Docket Number EPA-HQ-OAR-2011-0081  
Response to Petition From New Jersey Regarding SO<sub>2</sub>  
Emissions From the Portland Generating Station  
(76 FR 19662; April 7, 2011)

# Response to Comments Document

U.S. Environmental Protection Agency  
Office of Air and Radiation  
October 2011

Network 1-Hour Peak Time Series Fractional Bias with 95% Confidence Limits

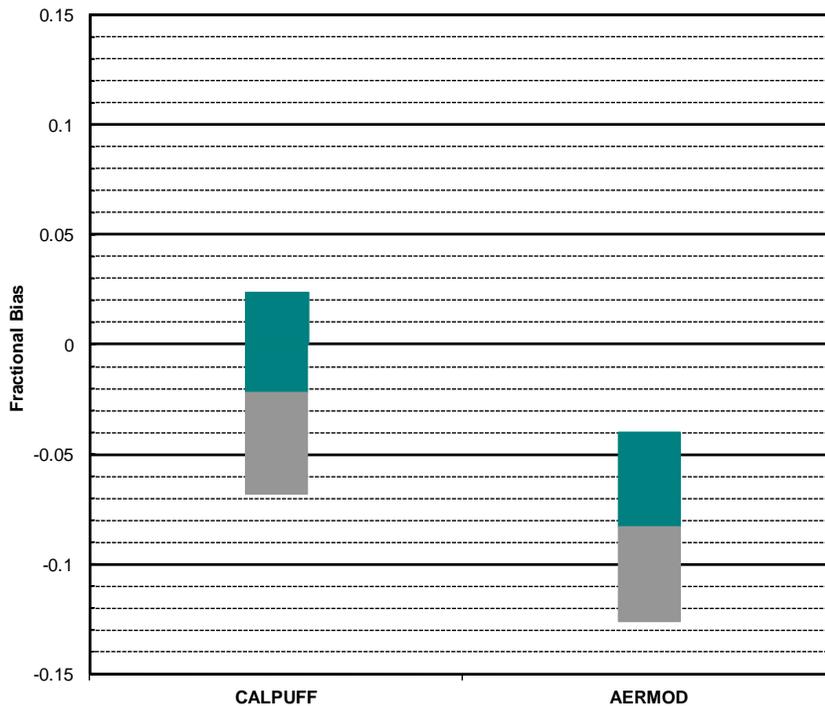
As discussed in the proposed rule modeling TSD, there are several aspects of the evaluation procedures used by NJDEP in their CALPUFF validation study that EPA has taken issue with, such as the varying choices of the number of samples (N) for calculating robust highest concentrations (RHCs), the use of residuals (ratios of predicted to observed concentrations) based on results paired by rank, and the inclusion of the AMS8 monitor in the model-to-monitor comparisons. However, even if those issues are set aside and NJDEP’s validation study is accepted at face value, their validation results do not support the contention that CALPUFF performs significantly better than AERMOD on this dataset in a statistical sense. We base this assessment on the only statistical model performance comparison included in the NJDEP validation study that would be appropriate to use to assess whether one model is performing significantly better (statistically) than the other model, namely the confidence limits on the fractional bias (FB) results based on the time series of network peak 1-hour values (paired in time), shown below (presented as Figure 10 in the NJDEP validation study):

These statistical evaluation results based on the network peak 1-hour time series serve as part of the diagnostic component of the evaluation rather than the operational component because they examine hourly modeled vs. observed results paired in time instead of focusing on the peaks of the concentration distributions. Both models show little overall bias in this comparison, with FBs of -0.022 for CALPUFF and -0.083 for AERMOD (note that negative FB indicates overprediction based on the formula used by NJDEP). Although the FB for CALPUFF is closer to 0 (zero) than AERMOD, the 95% confidence intervals of FB for CALPUFF and AERMOD overlap, indicating that the difference in performance between the two models is not statistically significant. This is comparable to the confidence intervals for model comparison measure crossing zero in the explanation cited above from the Cox-Tikvart protocol. In fact, NJDEP acknowledges this interpretation of Figure 10 on page 30 of their validation report stating that “[t]he model output also shows that the two models’ network 1-hour time series FBs are not significantly different from each other.” These statistical results based on the network peak 1-hour time series are also consistent with the general impression given by the Q-Q plots shown in Figure 8 of NJDEP’s validation report of similar overall performance between CALPUFF and AERMOD with both models showing generally good agreement with observations. Therefore, setting aside the technical issues associated with the evaluation methodology, these model evaluation results provided by NJDEP do not meet the threshold of demonstrating that CALPUFF performs “significantly better” than AERMOD in a statistical sense based on this particular field study evaluation.

It should also be noted that the FB results included in this figure based on the network peak 1-hour time series analysis were computed based on the average predicted vs. average observed concentrations across the full period of the field study, with a minimum value of  $16 \mu\text{g}/\text{m}^3$  being assigned to all monitored or modeled concentrations that were less than  $16 \mu\text{g}/\text{m}^3$ , which is considered to be the detection limit for the  $\text{SO}_2$  monitors. Since the fractional bias is computed based on the average concentration rather than paired 1-hour values, the aspect of pairing results in time for this analysis is only relevant from the perspective of the bootstrap resampling conducted to determine confidence limits on the results, such that the temporal pairing of predicted vs. observed concentrations is preserved in the resampling of the results. The fact that the FB comparisons from the network peak 1-hour time series analysis are actually computed based on average concentrations also diminishes the relevance of these results in terms of assessing the performance of these models for predicting the peak of the distribution of hourly concentrations which is an important aspect of the operational evaluation.

**Figure 1. Model Comparison Measure for Martin's Creek Evaluation without PRIME Downwash in CALPUFF (MCM < 0 means AERMOD performs better than CALPUFF)**

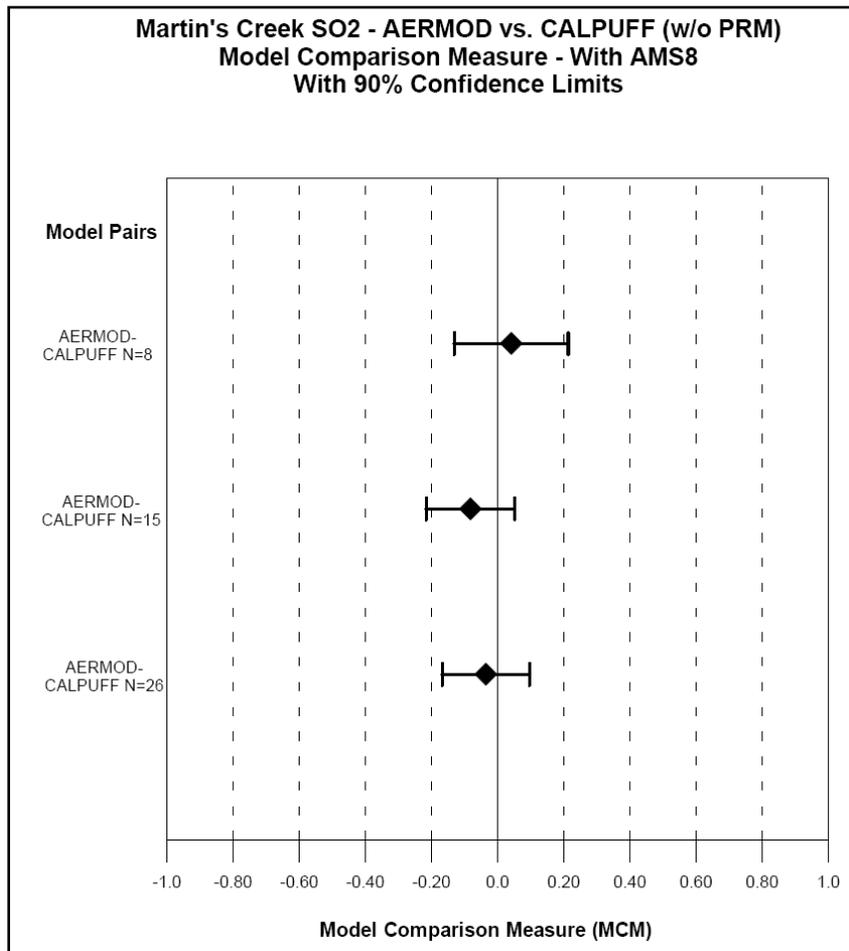
model comparison measure (MCM) results for this independent assessment are presented in Figure 1.

A value of 0.0 for MCM indicates that the CPM is the same for each model, a value of MCM less than 0.0 in this case indicates that AERMOD performs “better” than CALPUFF and a value of MCM greater than 0.0 indicates that CALPUFF performs “better” than AERMOD. In either case, if the confidence interval crosses 0.0, the difference in performance between the two models is not statistically significant at the 90% confidence interval. Figure 1 shows that AERMOD performs slightly better than CALPUFF for N=26 and N=15, but CALPUFF performs slightly better for N=8. However, the confidence intervals on the MCMs cross 0.0 in all cases indicating that differences in model performance are not statistically significant at the 90% confidence level. Similar to the fractional bias results for the network peak 1-hour time series reported by NJDEP, the results from EPA’s independent assessment based on the Cox-Tikvart protocol are consistent with the general impression given by the Q-Q plots included in NJDEP’s validation report.

**Figure 5. Q-Q plots of 1-hour Network-wide SO2 for Martin’s Creek Based on Meteorological Category (based on Figure 1 (from Appendix A to NJDEP’s Comments).”**

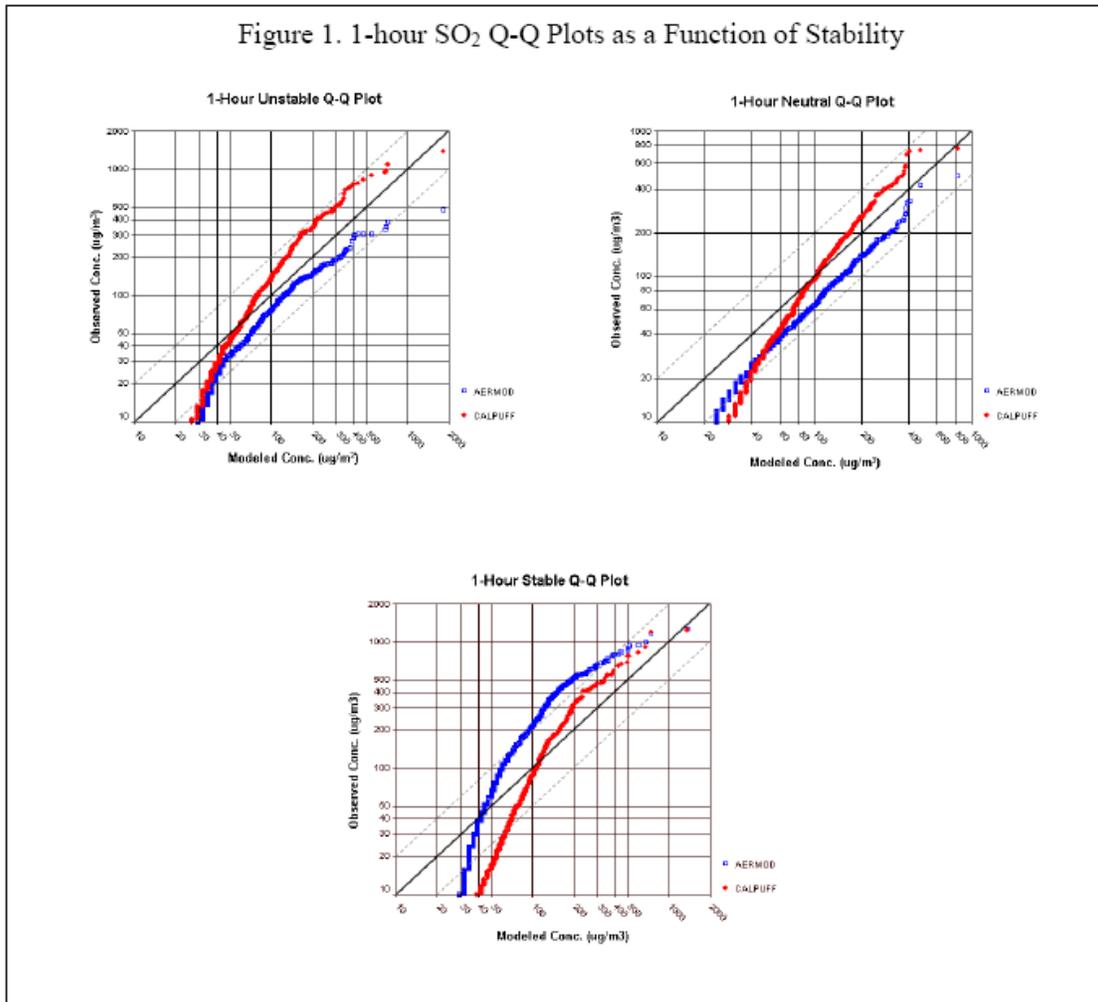
the distribution exceeding the factor of 2 observations line. CALPUFF shows the same tendency to over-predict during all stability regimes.

EPA’s contention that AERMOD and CALPUFF show very similar concentration distributions focused solely on the comparison of each model’s overall concentration distribution Q-Q plots and discounted the other statistical results submitted by NJDEP in the model validation study. The newly generated Q-Q plots in Figure 1 indicate poor model performance for AERMOD in complex terrain around Martins-Creek when the concentration distributions are pooled by stability regime.”

**Response:**

Figure 1 of NJDEP’s comments (shown above as Figure 5) provides Q-Q plots by stability category, which NJDEP asserts demonstrate that AERMOD is biased toward underprediction. Note that the axes in these Q-Q plots appear to be reversed; the vertical axis should be the predicted concentrations and the horizontal axis should be the observed concentrations (otherwise the plots would suggest that CALPUFF significantly underpredicts). Pooling of data

**Figure 7. Q-Q Plot of Predicted vs. Observed Values Paired by Rank for Hypothetical Distributions.**

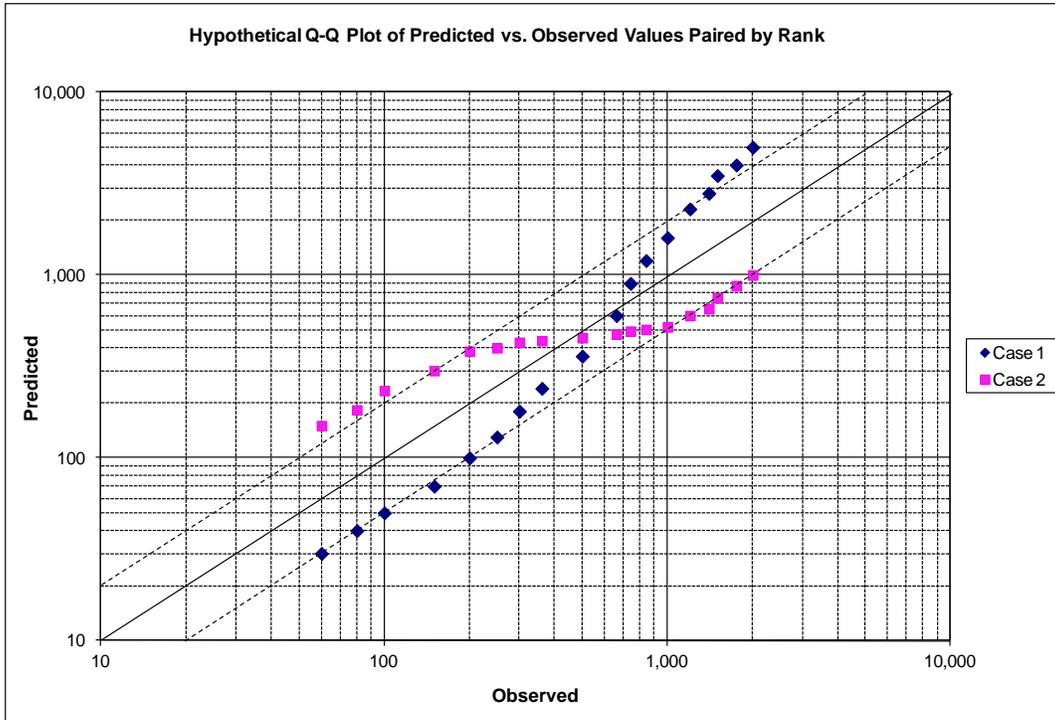
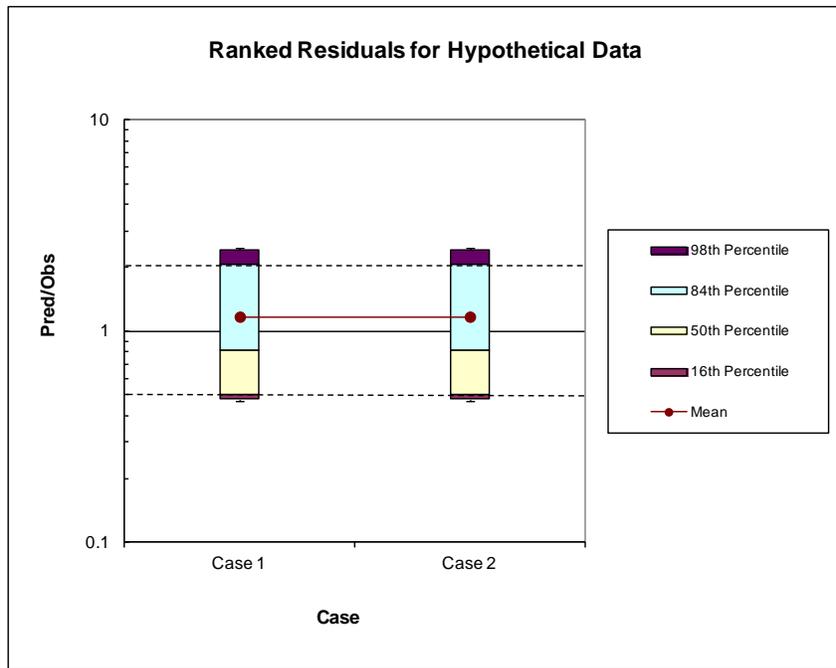
The following hypothetical example should serve to illustrate these concerns regarding the use of residual plots with predicted/observed ratios paired by rank. Figure 7 shows a Q-Q plot of predicted-vs.-observed concentrations paired by rank for two hypothetical cases. This figure clearly shows that Case 1 overpredicts the upper end of the observed distribution by more than a factor of 2 while Case 2 underpredicts the upper end of the distribution by a similar amount. These biases are reversed for the lower end of the distributions. Figure 8 presents a comparison of residuals for these two hypothetical distributions, based on ratios of predicted/observed values paired by rank, using the same method of plotting residuals as used by NJDEP in Figure 9 of their validation study. The residual plots in Figure 8 for these two hypothetical distributions are exactly identical, i.e., the distribution of the predicted/observed ratios of concentrations paired by rank is identical between these two hypothetical cases. In this hypothetical case the residual plots paired by rank mask the important difference between these two distributions that is clearly highlighted in the Q-Q plots, which is that one distribution shows a significant bias to overestimate the peak concentrations and the other distribution is biased to underestimate the peak concentrations. In other words, the distribution of predicted/observed concentration ratios paired by rank has no meaning or relevance to the assessment of model performance and could mask significant differences between models.

Figure 2. CALPUFF Predictions of the 99th Percentile 1-Hour Sulfur Dioxide Impacts with 1992-1993 Meteorological Data

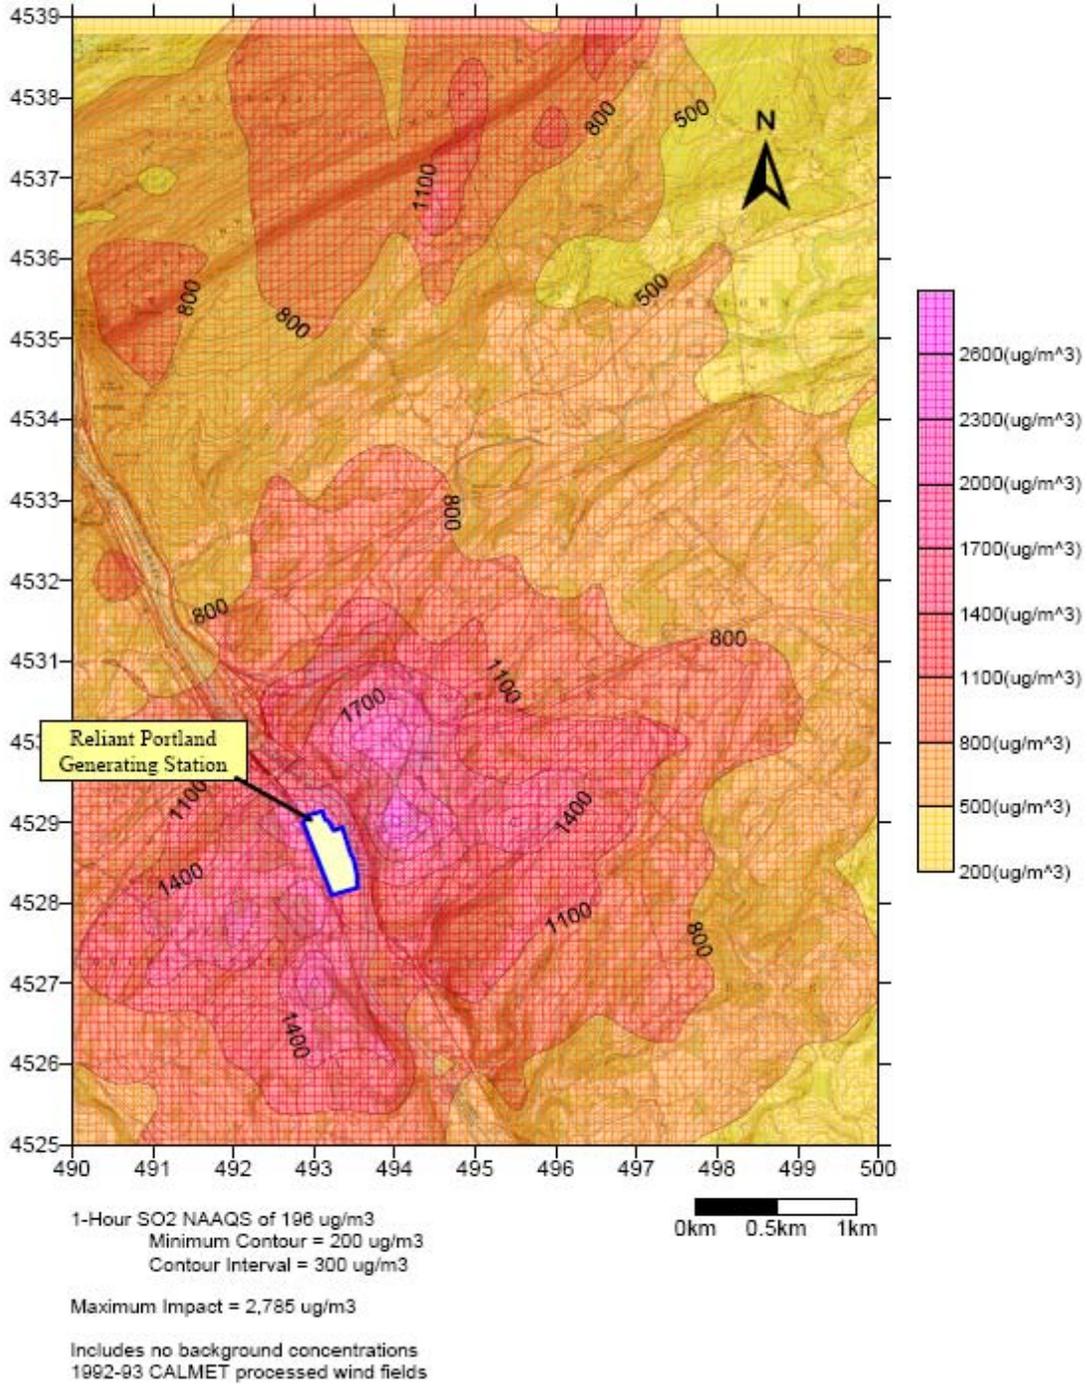
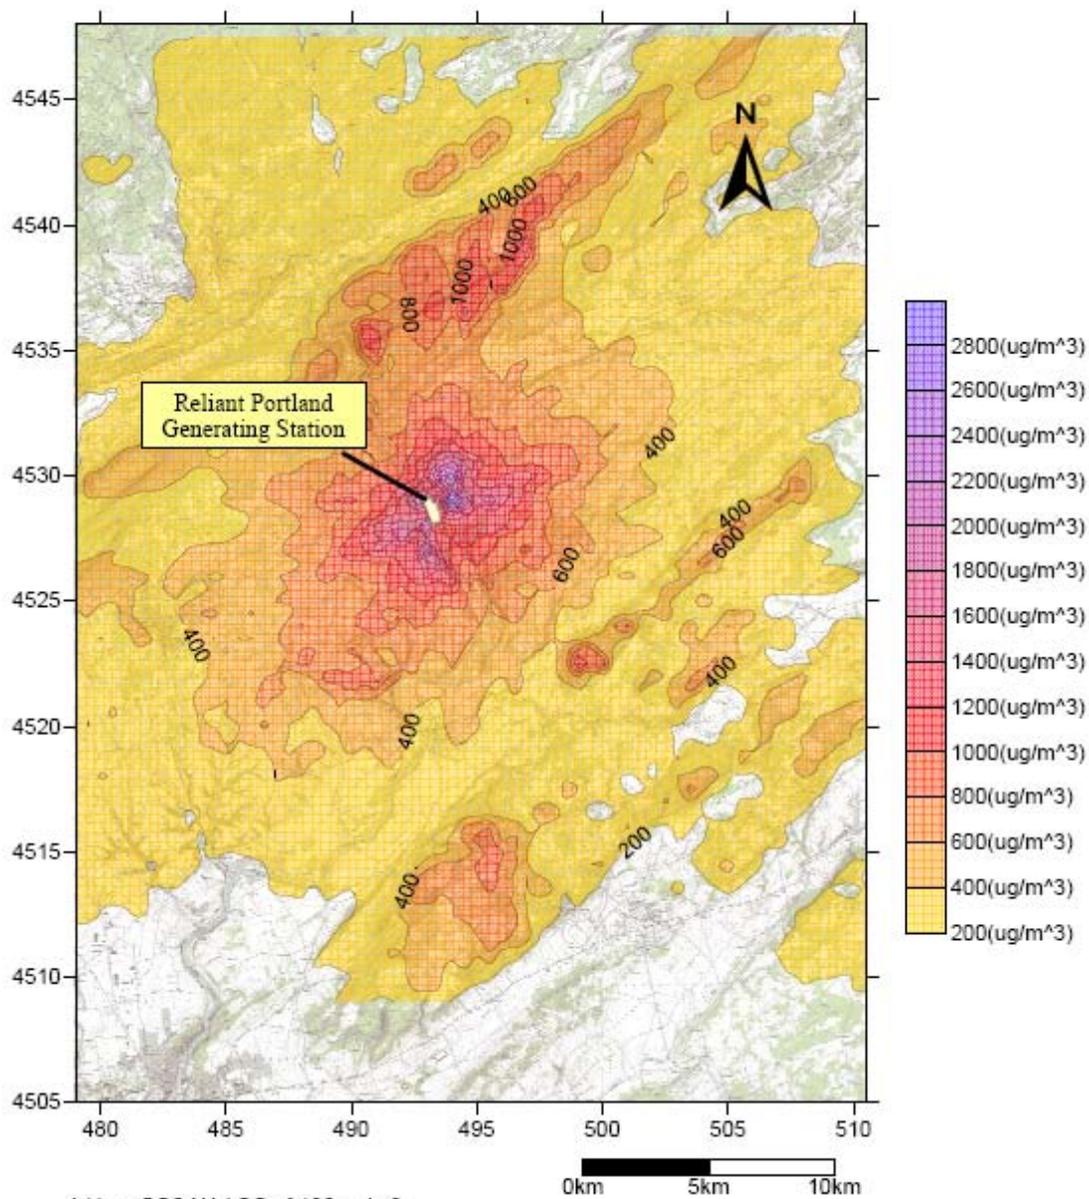
*“NJDEP Response 4.b - EPA has raised the concern that the Supplemental 126 Petition CALPUFF modeling did not include on-site meteorological data such as that used in NJDEP’s validation study. This concern can first be addressed by looking at the exhibits of NJDEP’s first 126 petition that was submitted to EPA on May 12, 2010. Exhibit 10 of that submittal is entitled “Calpuff 1992-1993 Modeling Analysis of the Sulfur Dioxide Impacts due to Emissions from Portland Generating Station”, dated February 25, 2010. This document details CALPUFF modeling of the allowable SO<sub>2</sub> emissions from Portland using the same meteorological data as used in NJDEP’s model validation study. The results of this modeling predicted the SO<sub>2</sub> impacts caused by Portland would be 67 percent higher than 3-hour NAAQS and over twice the SO<sub>2</sub> 24-hour NAAQS. Exhibit 6 of the May 12, 2010 126 Petition (Attachment II to this appendix) shows that when modeling the allowable emissions from Portland, use of the 1992-93 meteorological data results in predicted 3-hour and 24-hour impacts equal to or higher than those predicted with the 2002 and 2003 MM-5 meteorological dataset.*

*EPA's concern regarding NJDEP's meteorological data was next addressed with additional CALPUFF modeling to determine compliance with the 1-hour SO<sub>2</sub> NAAQS using the same 1992-93 meteorological data used by CALPUFF in the model validation. The results of the modeling analysis are shown in Figures 2 and 3. The CALPUFF model results using the on-site model validation meteorology data set produce impacts that are consistent both in spatial distribution and magnitude with the previous CALPUFF results submitted by NJDEP in support of the Supplemental 126 Petitions. Out of 8,280 receptors covering an area of approximately 30km by 40 km, 6739 receptors were found to have impacts above the National Ambient Air Quality Standard (see Figure 3). The maximum predicted violation of the 1-hour SO<sub>2</sub> NAAQS due to emissions of Portland Power Plant was 2,785 ug/m<sup>3</sup>. At this receptor with the maximum impact (494.000 km E, 4,528.800 km N), 153 days were predicted to exceed the National Ambient Air Quality Standard. A 94 percent reduction in Portland Power Plant's allowable SO<sub>2</sub> emission rate would be needed to bring this receptor into compliance with the 1-hour SO<sub>2</sub> NAAQS."*
